Hartland Township Planning Commission Meeting Agenda Memorandum

Subject: Site Plan Application #21-014 Multi-tenant building with drive-through window (Hartland Towne Square PD)

SITE PLAN #21-014 (REQUEST TO AMEND FINAL PLAN AND CONSTRUCT MULTI-TENANT BUILDING WITH DRIVE-THROUGH WINDOW)

DUMPSTER ENCLOSURE PLAN

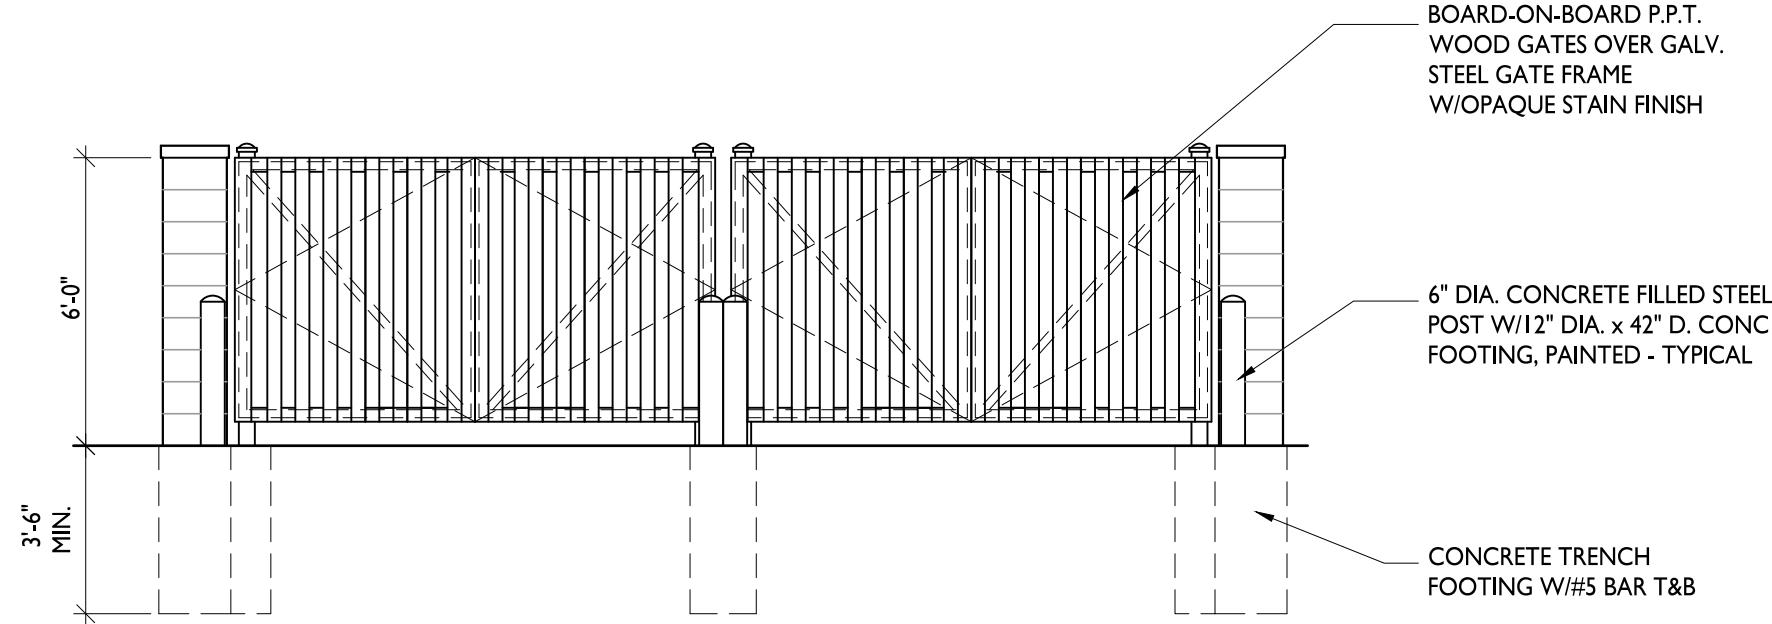
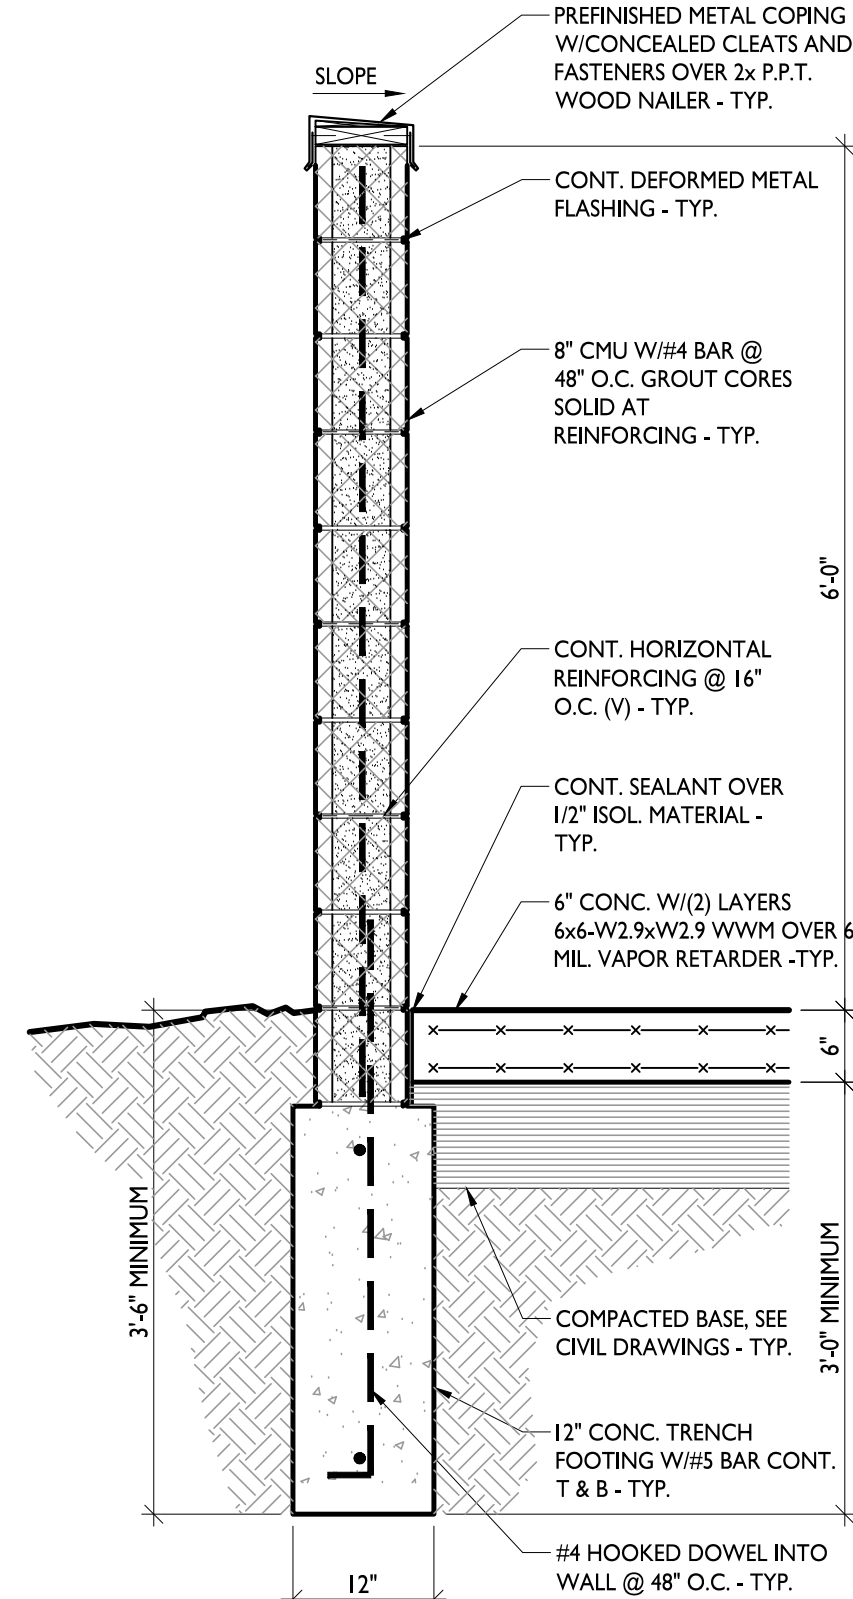
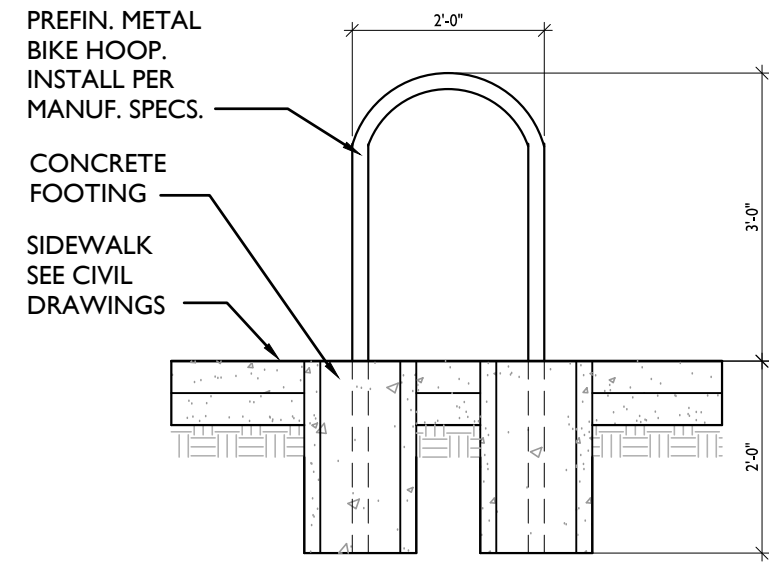
- Proposed – A screened refuse enclosure, with two stalls and wooden gates is provided in the northwest corner of the site, with a 6-foot high screen wall comprised of CMU (Sheet SP 1.01)

- Comments – **Revised drawings of the dumpster enclosure (brick to be used in place of CMU) will be required as part of the construction set of plans.**

2. The applicant shall change the building materials of the dumpster enclosure to match the building elevations. Revised plans shall be submitted as part of a land use permit.

BIKE HOOP

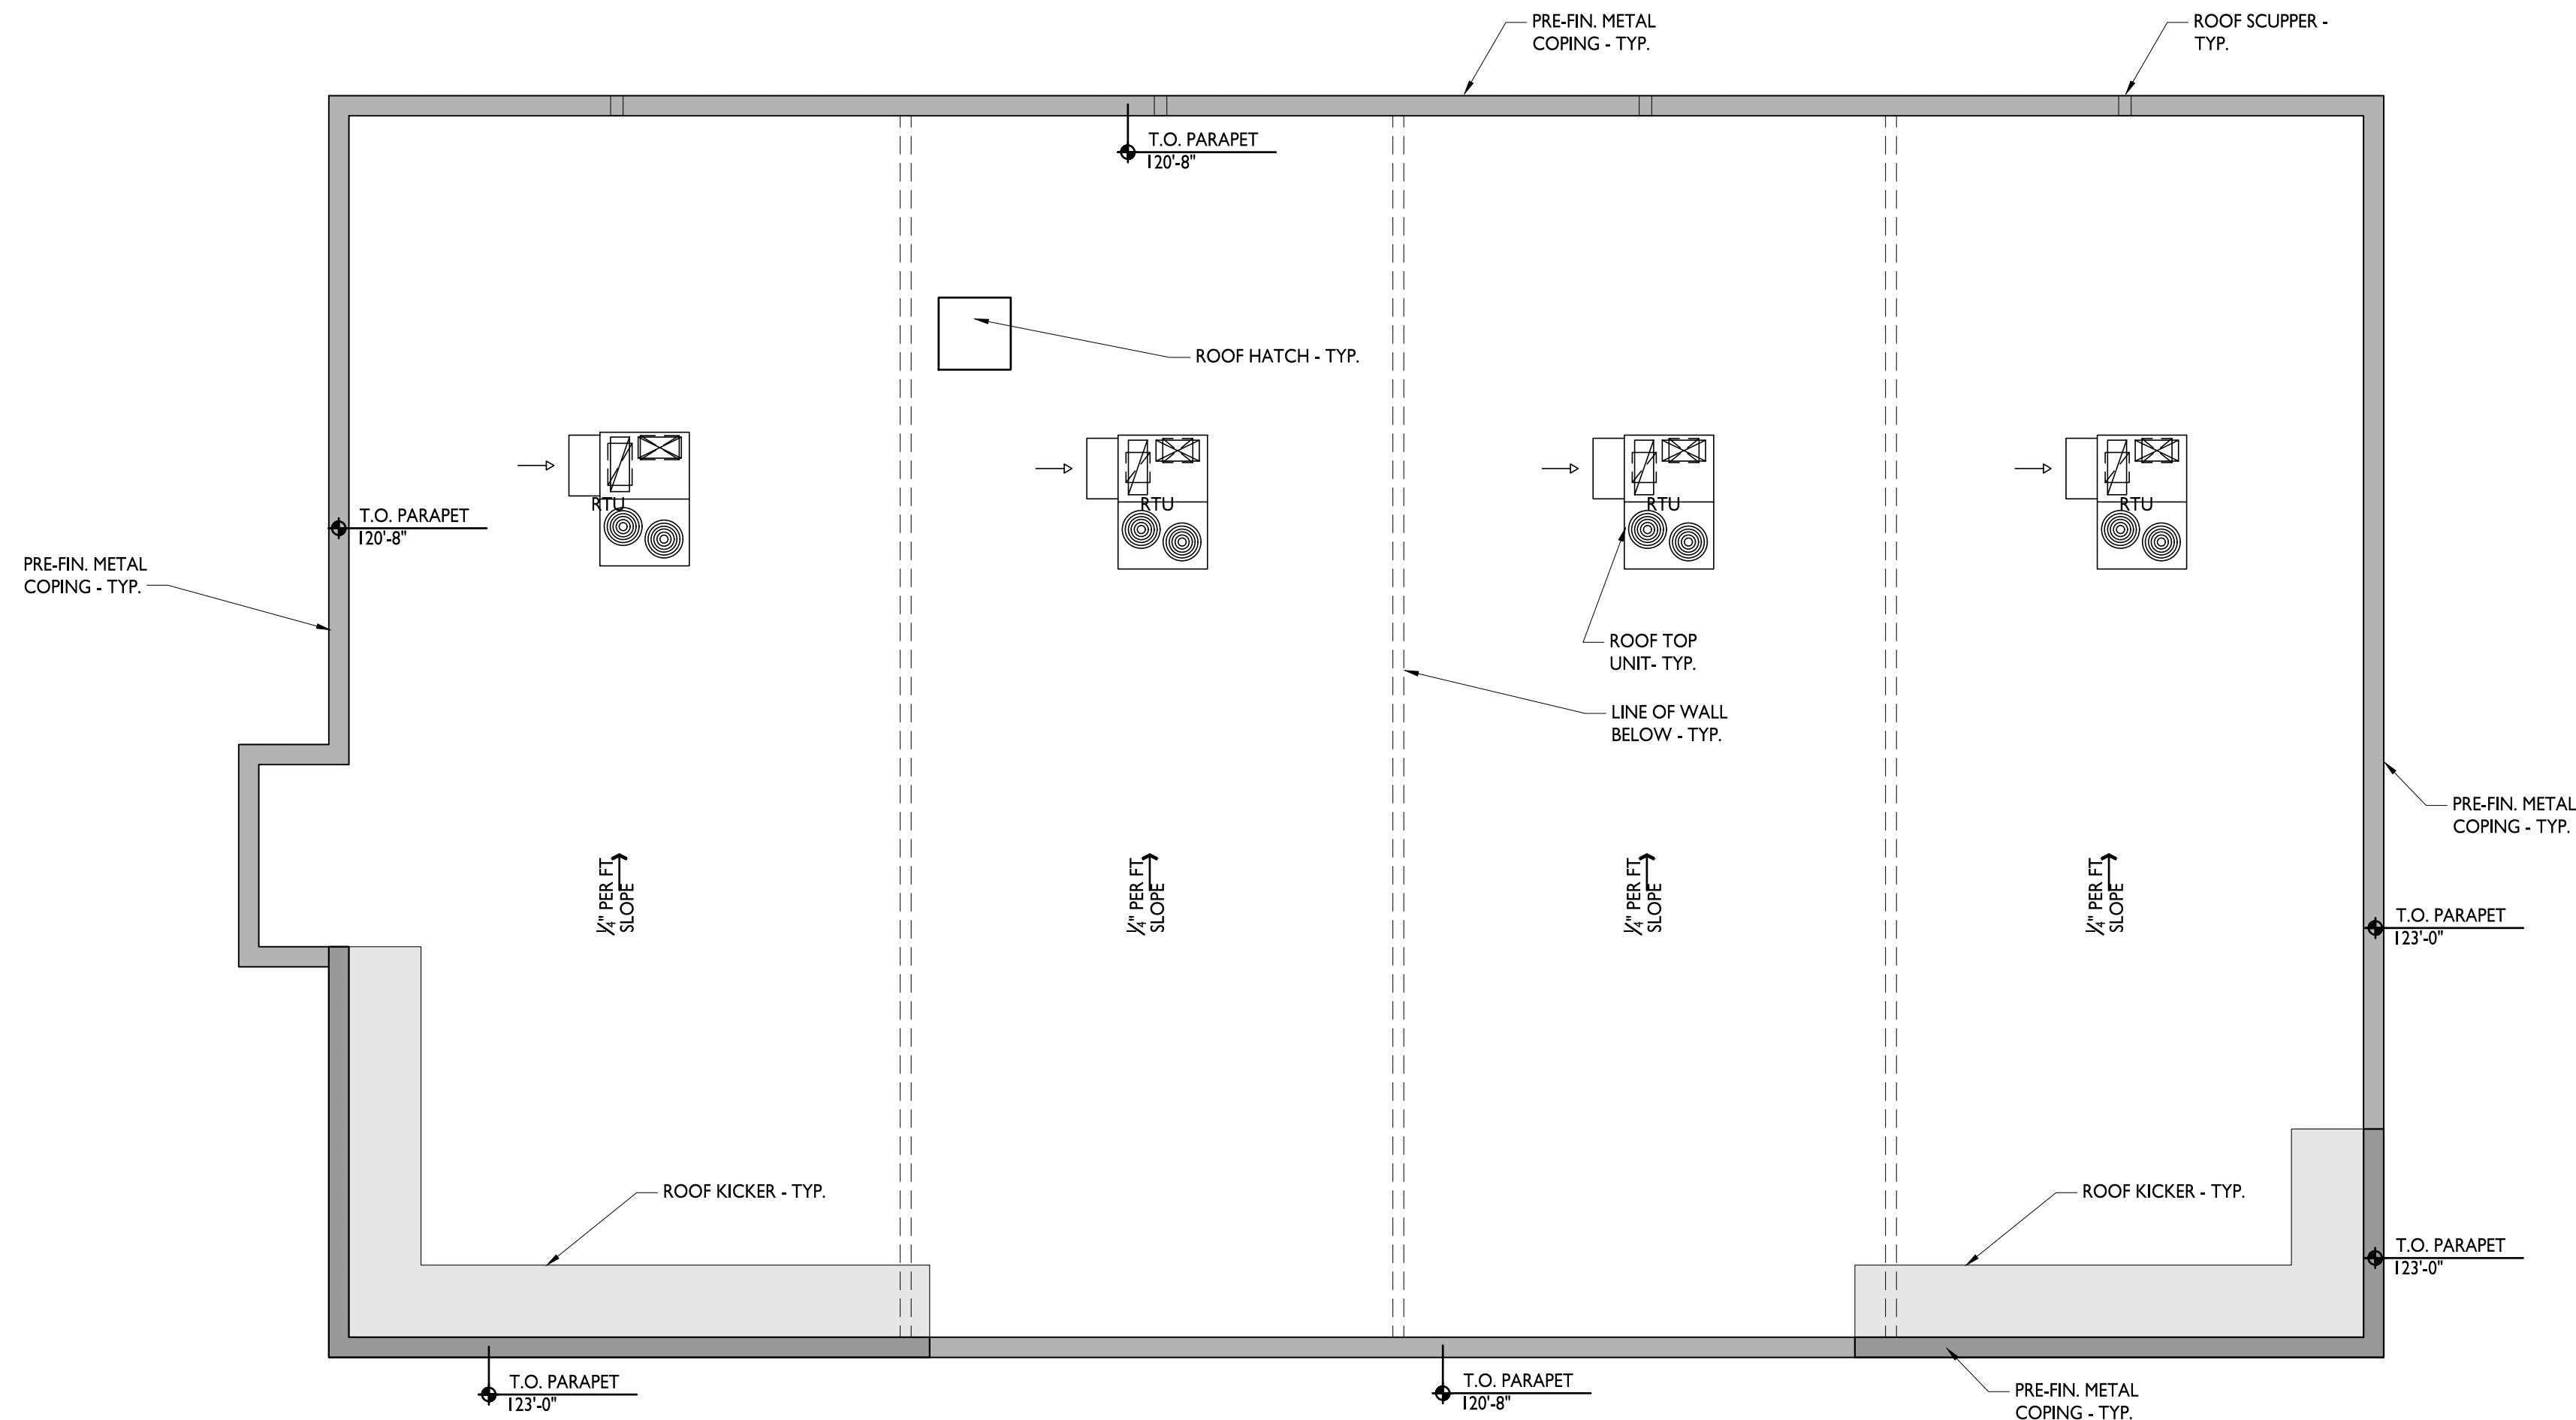
- Transformer – If a transformer is proposed, the unit should be shown on the plans and all required screening.
- Bike Racks – A detail drawing of a bike hoop is provided on Sheet SP 1.01 however the bike hoop is not shown on the plans.
- Ground Sign – A monument sign is shown on the plans. The Pattern Book provides design standards for a monument sign regarding size, height and type of building materials (Page 27A of the Pattern Book). A monument sign, if proposed, will be reviewed as part of a sign permit application.
- Wall Sign – Wall sign standards are provided in the PD Agreement (Section 6.6). Signs will be reviewed as part of a sign permit application.

1 WEST ELEVATION
A5.01 A5.01 SCALE: 1/4" = 1'-0"

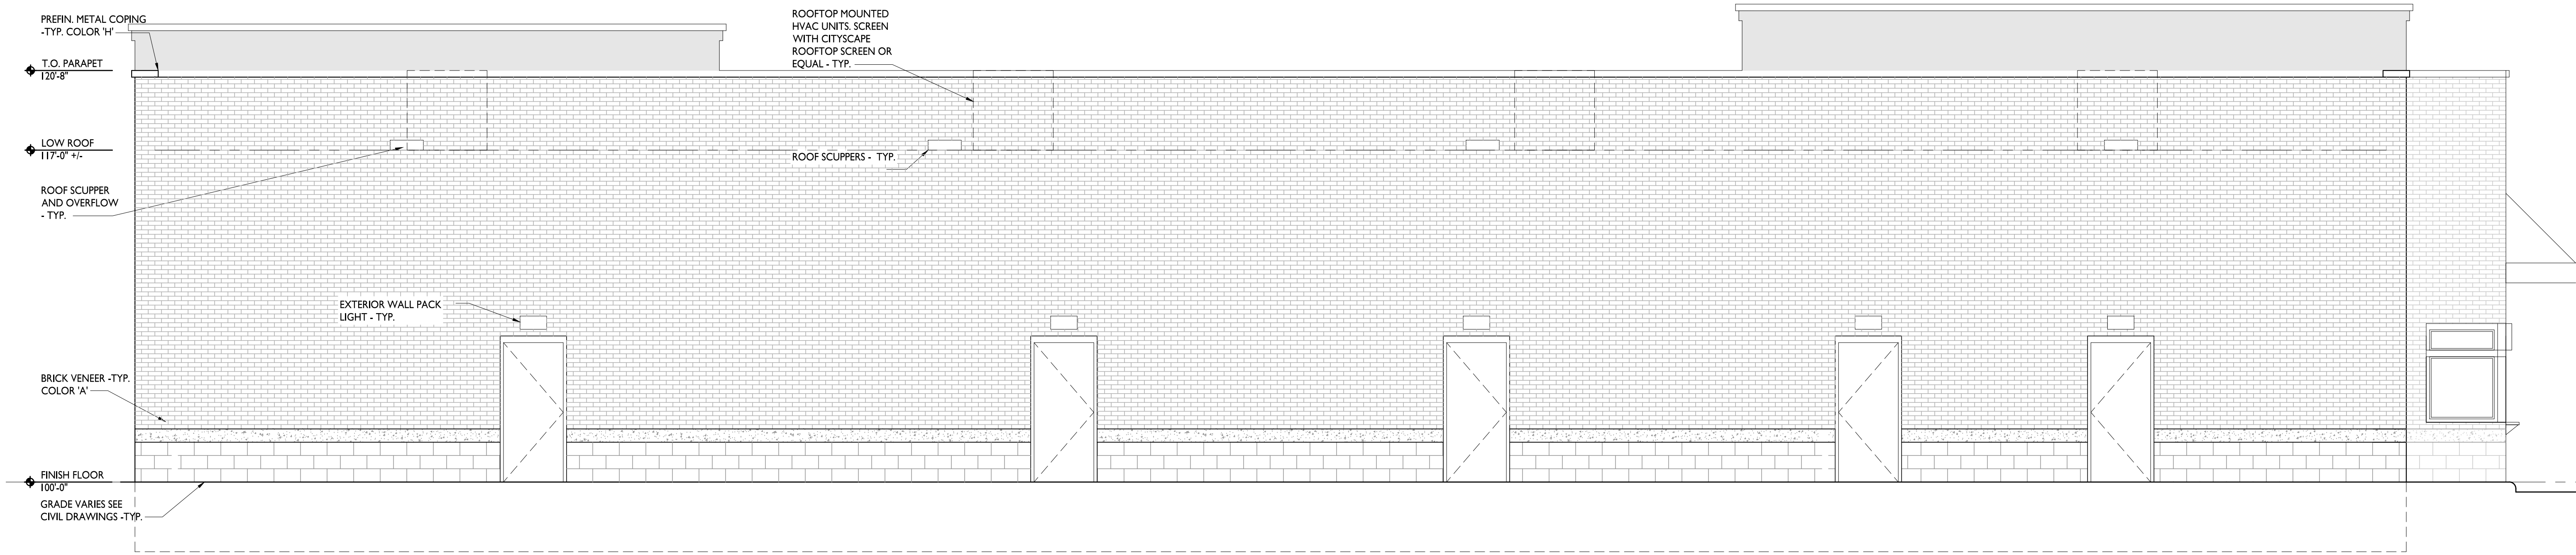
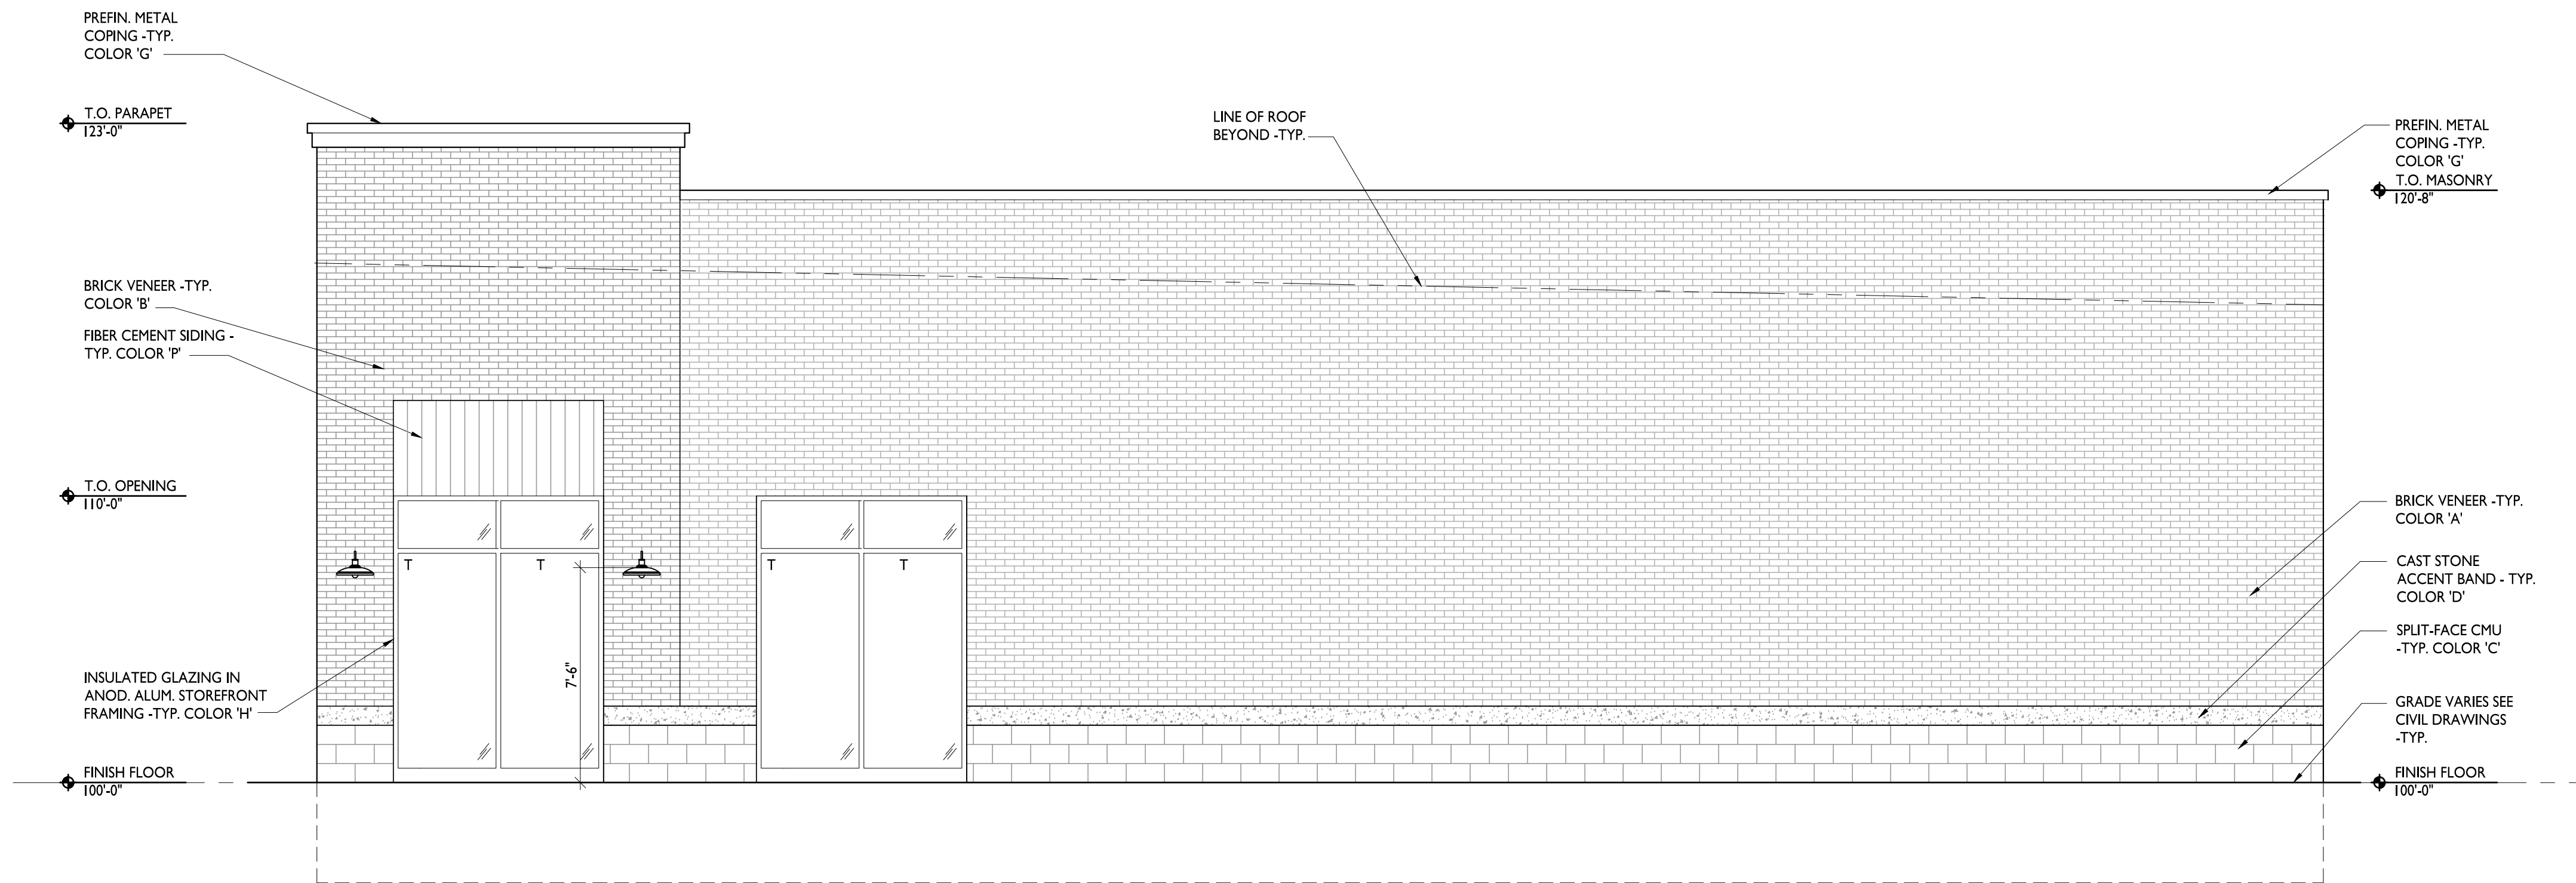
*Applicant has noted in an email dated 10/4/2021, that the percentages for split-face CMU and brick are flipped in the chart on Sheet A5.01R (Façade Materials Calculations N & W). The correct percentages for brick and split-face CMU are listed above. Also, on that same sheet, cast stone is shown on the west elevation (64.88 square feet) however the percentage is listed as 0% in the chart, and should be revised.

Parapet walls are shown, as well as the line of roof beyond the walls, on the north, south, and west elevation drawings. The line of roof beyond the wall is not shown on the east (front) elevation drawing. Sheet A5.01 (see west elevation) states the "rooftop mounted HVAC units,
